Access Compliance Report

Public Rights-of-Way

Intersection ID: 10027253	Main Street: GLAZER_VALLEY_CT	Cross Street: N/A	Location: SE
ADA ID: 5E130EEC2BF1	Ramp Type: Perp	Initial Pass/Fail: Pass	Overall Compliance: No
		Severity Score: 0.25	
Codes/Mitigation Info/Possible Solution		Field Measurements/Component Compliance

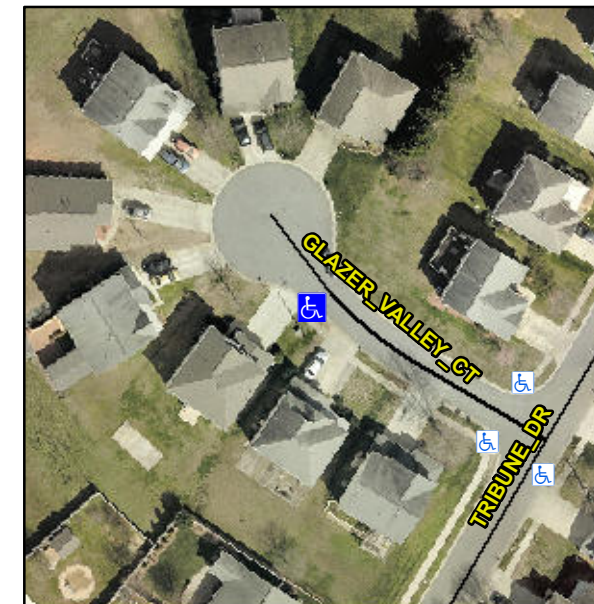
Not Found, R304.5.3, R304.2.2-Perp, R304.3.2-Para, R305.2

Compliance	Description	Data	Compliance	Description	Data
N/A	Ramp Length (in)	53.0	Yes	Ramp Slope (%)	6.8
Yes	Ramp Width (in)	48.0	No	Ramp XSlope (%)	3.2
N/A	Flare Type LT	Sloped	N/A	Flare Type RT	N/A
N/A	Flare Slope LT (%)	3.2	N/A	Flare Slope RT (%)	6.2
N/A	Flare Traversable LT?	Yes	N/A	Flare Traversable RT?	No
Yes	Landing Length (in)	48.0	Yes	DWS Provided?	Yes
Yes	Landing Width (in)	48.0	Yes	DWS Contrast?	Yes
No	Landing Slope (%)	2.2	Yes	DWS Length (in)	24.5
Yes	Landing X Slope (%)	2.2	Yes	DWS Full Width?	Yes
N/A	Landing Curb? (Y/N)	No	No	DWS Offset (in)	2.5
N/A	Shared Landing?	No			
Yes	Gutter Ponding?	No	Yes	Gutter Slope (%)	3.3
Yes	Gutter Lip Ht (in)	0.0	Yes	Gutter X Slope (%)	1.0
N/A	Painted X Walk1?	No	N/A	Painted X Walk2?	N/A
	X Walk 1 Direction	To E		X Walk 2 Direction	N/A
N/A	X Walk 1 Width (in)	N/A	N/A	X Walk 2 Width (in)	N/A
	X Walk 1 Slope (%)	2.8		X Walk 2 Slope (%)	N/A
	X Walk 1 X Slope (%)	2.5		X Walk 2 X Slope (%)	N/A

Remove & Replace Entire Ramp.
